ADDENDUM No. 2

LINK – Multi-Use Development

BID PACKAGE – All Trades

April 17, 2023

HARDSCAPE PLAN

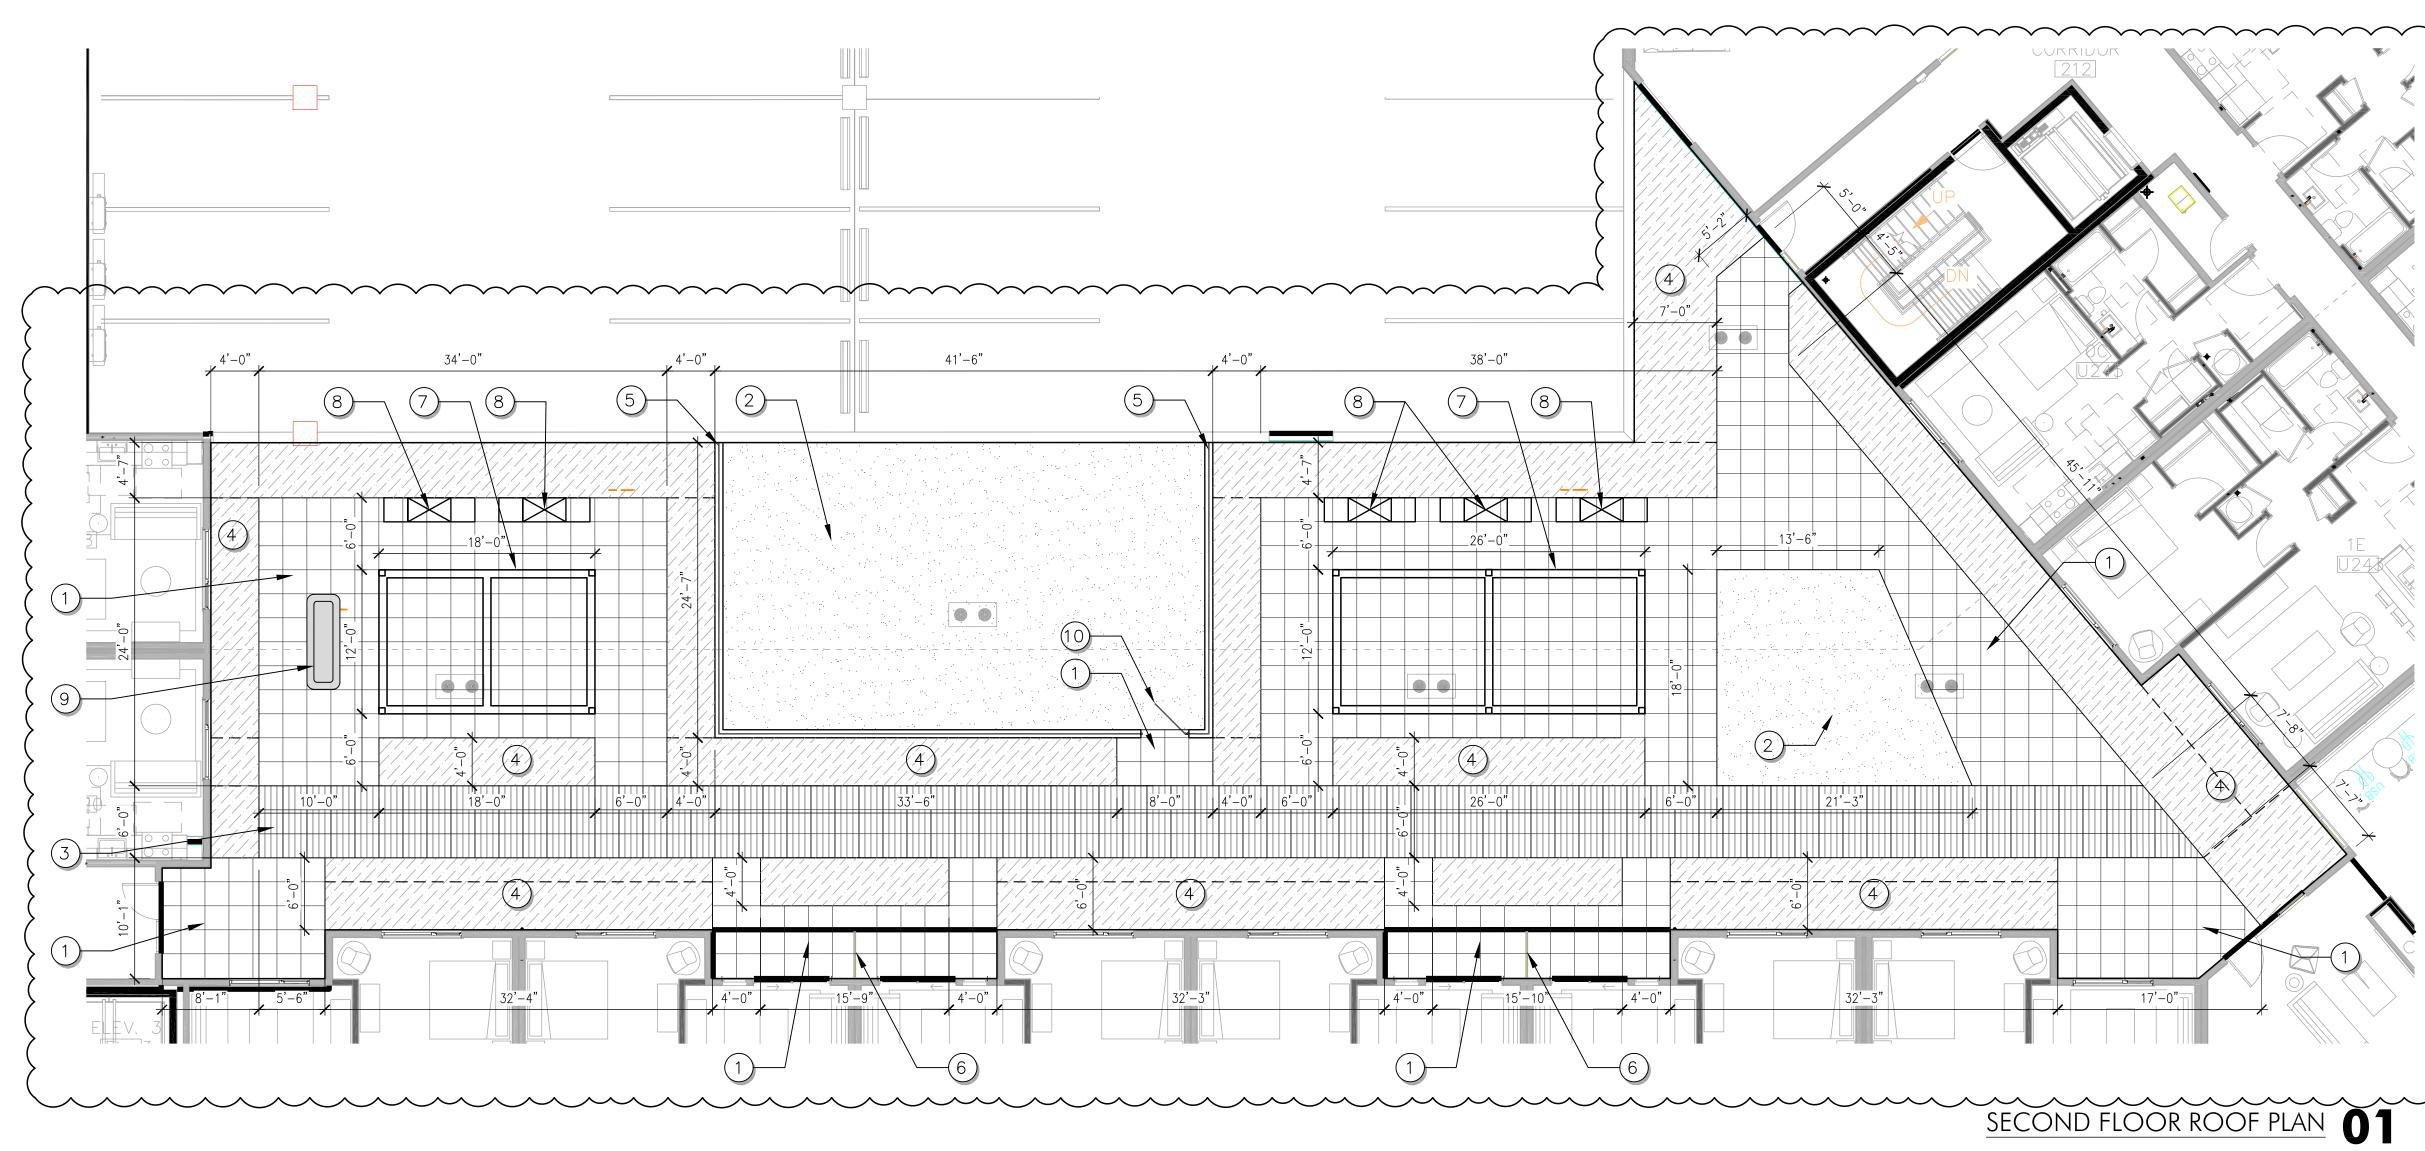
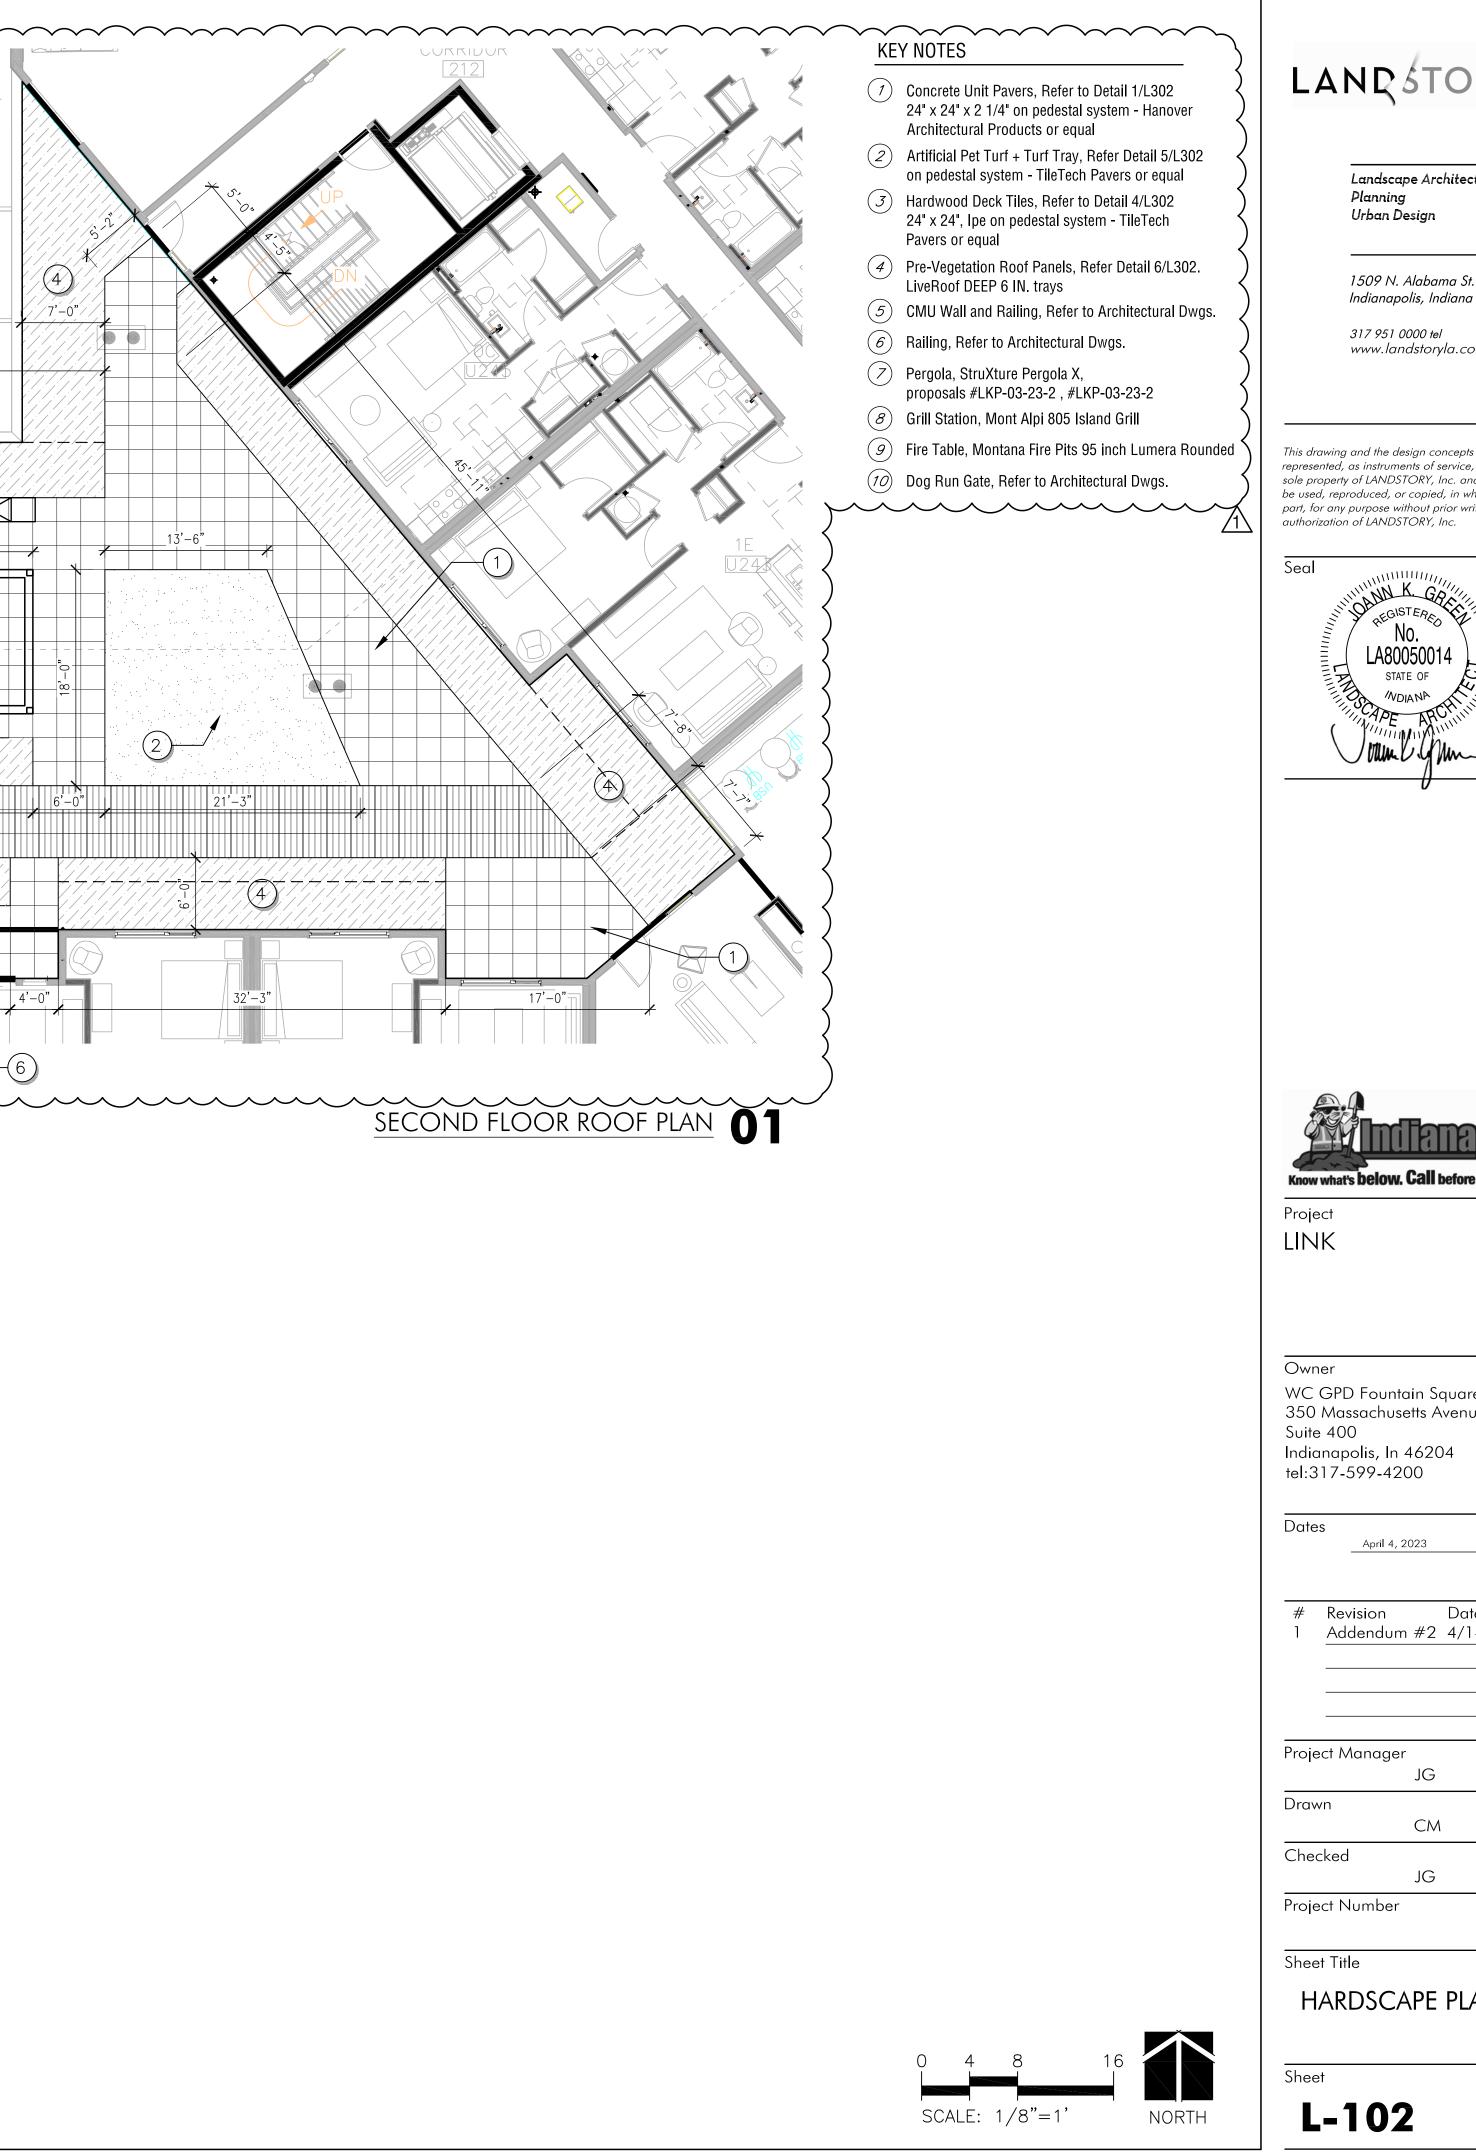
- Landscape
 - o L-101
 - Revised Key Notes schedule.
 - o L-102
 - Revised dog run extents.
 - Revised Key Notes schedule.
 - o L-202
 - Added LiveRoof Plant Schedule.
 - Revised LiveRoof layout.
 - Revised dog run extents.
 - Revised Key Notes schedule.
 - o L-301
 - Added detail 5.

A001

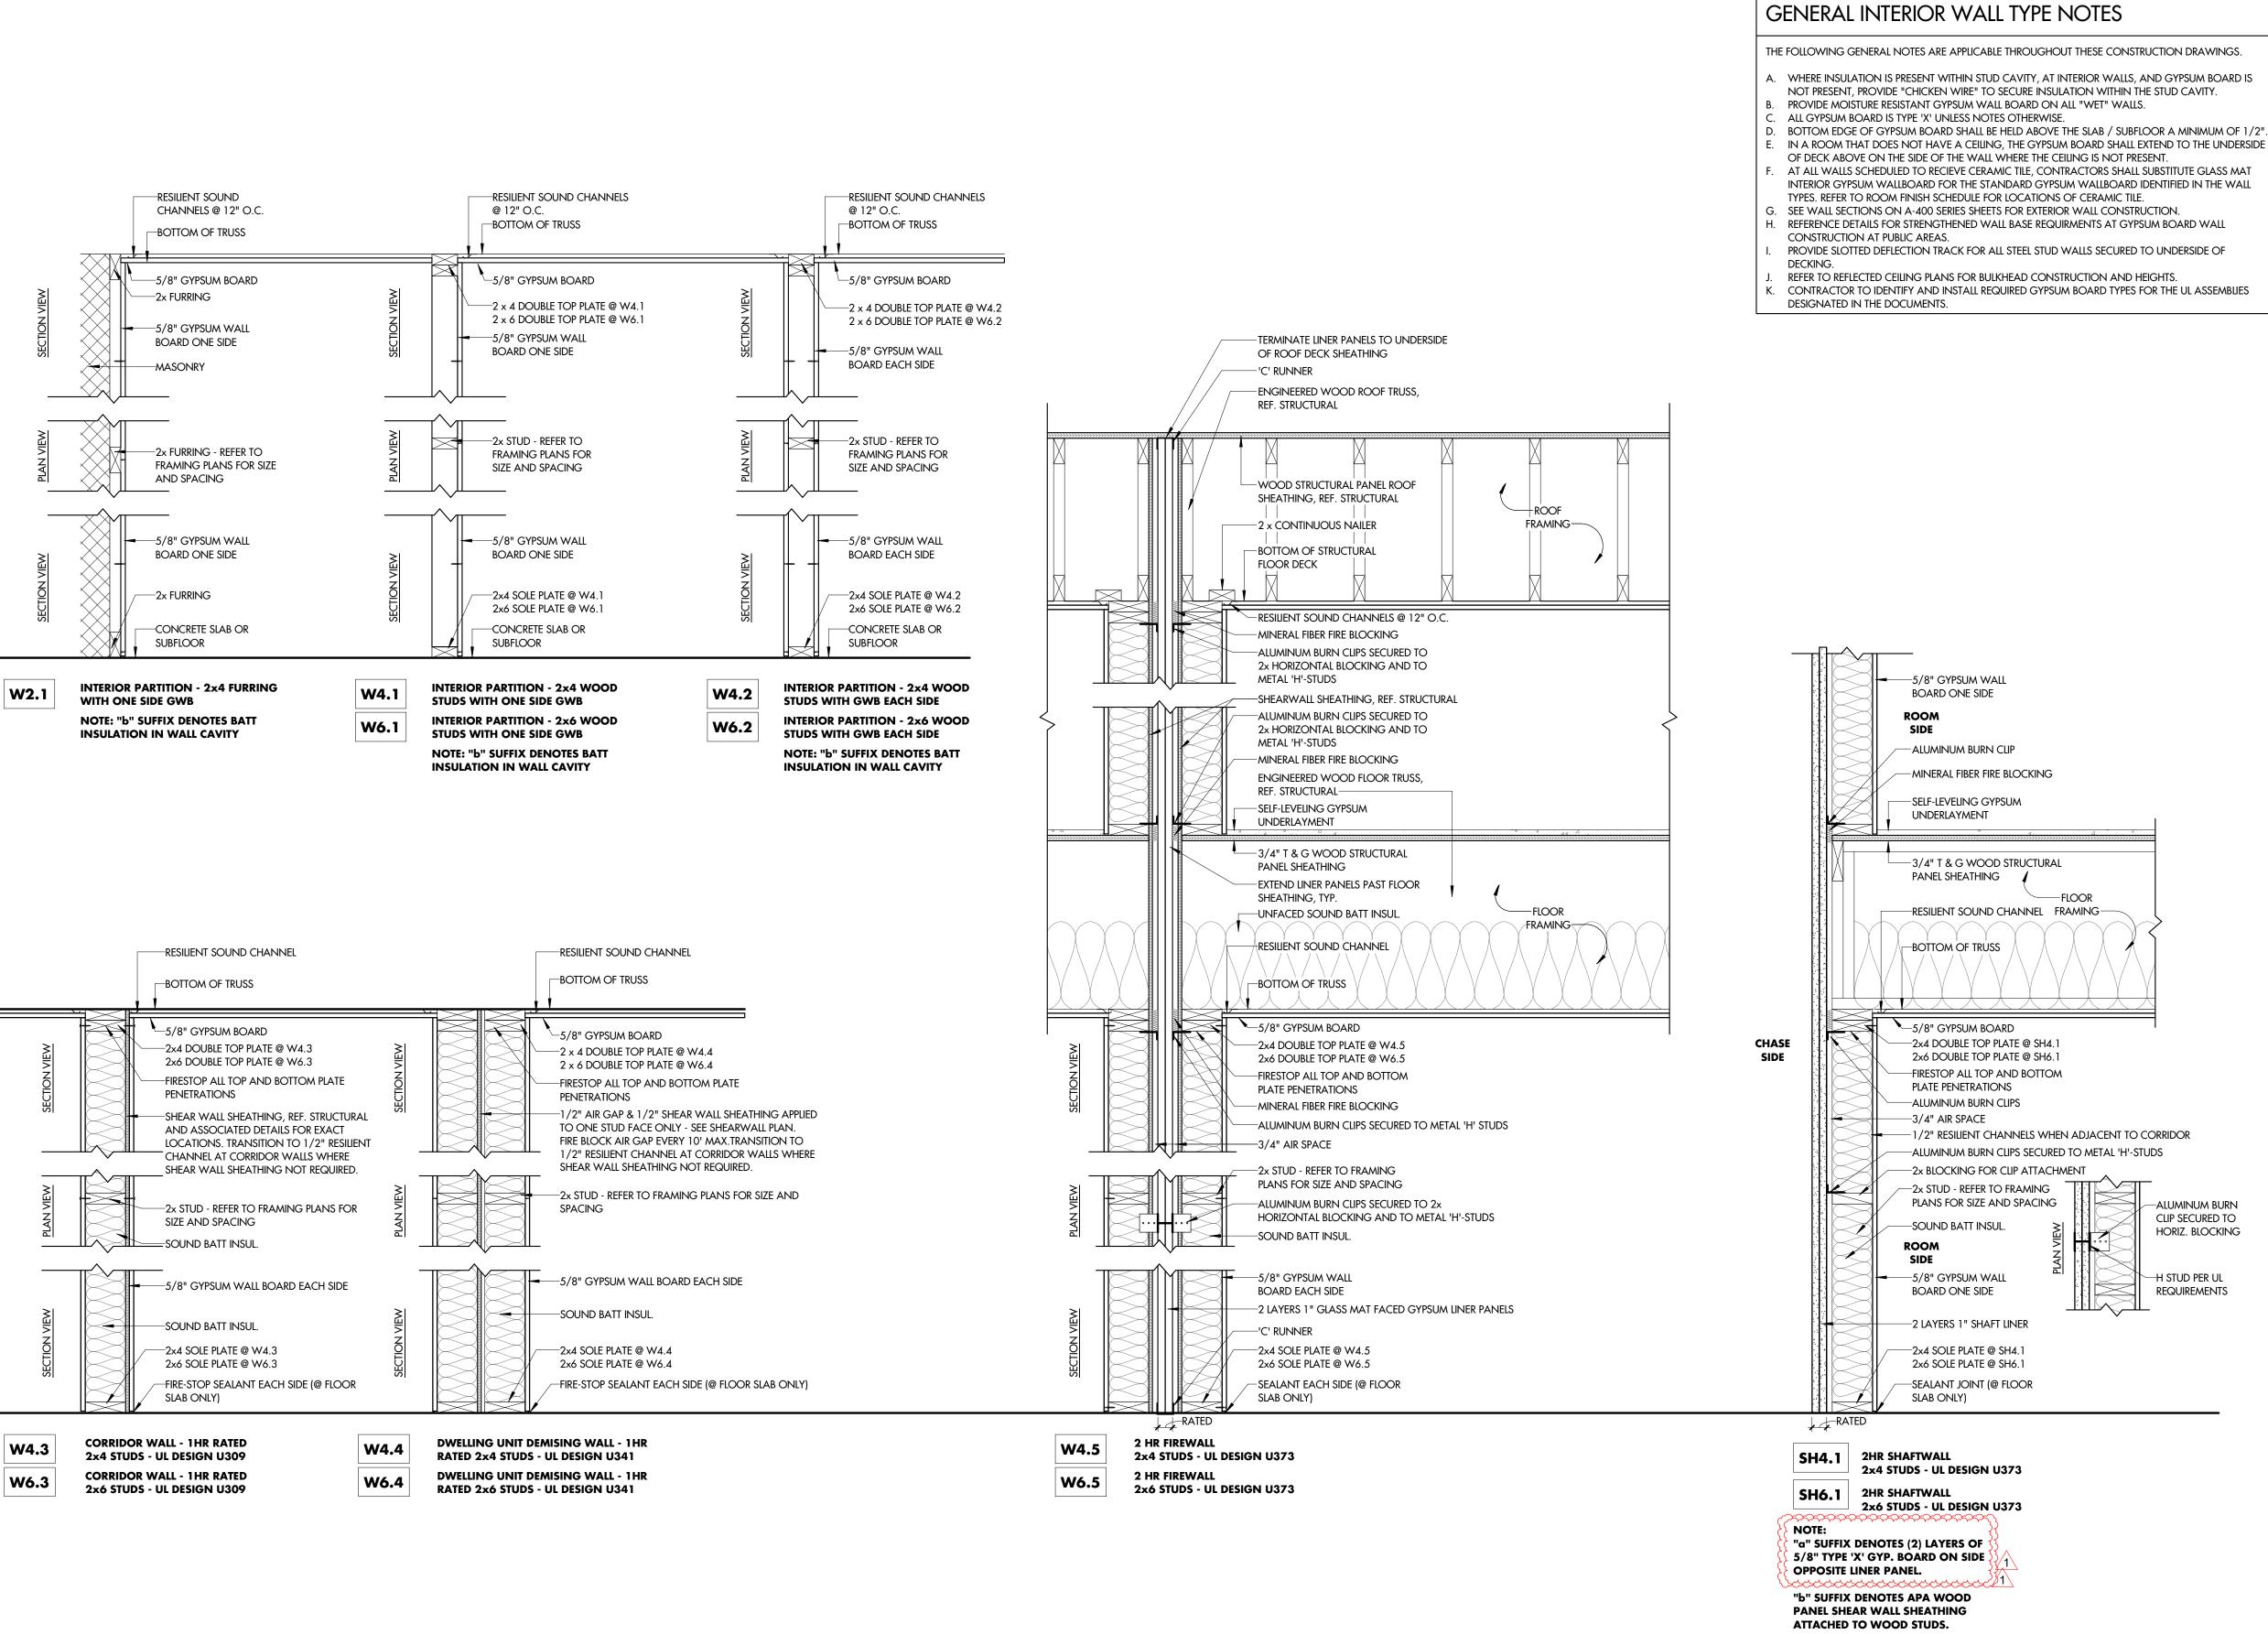
- o A001
 - Revised shaft wall note "a" to read (2) layers of 5/8" type 'X' gyp board.
- o A101.1
 - Revised parking. Added (2) ADA spaces.
 - Delete Door 135.
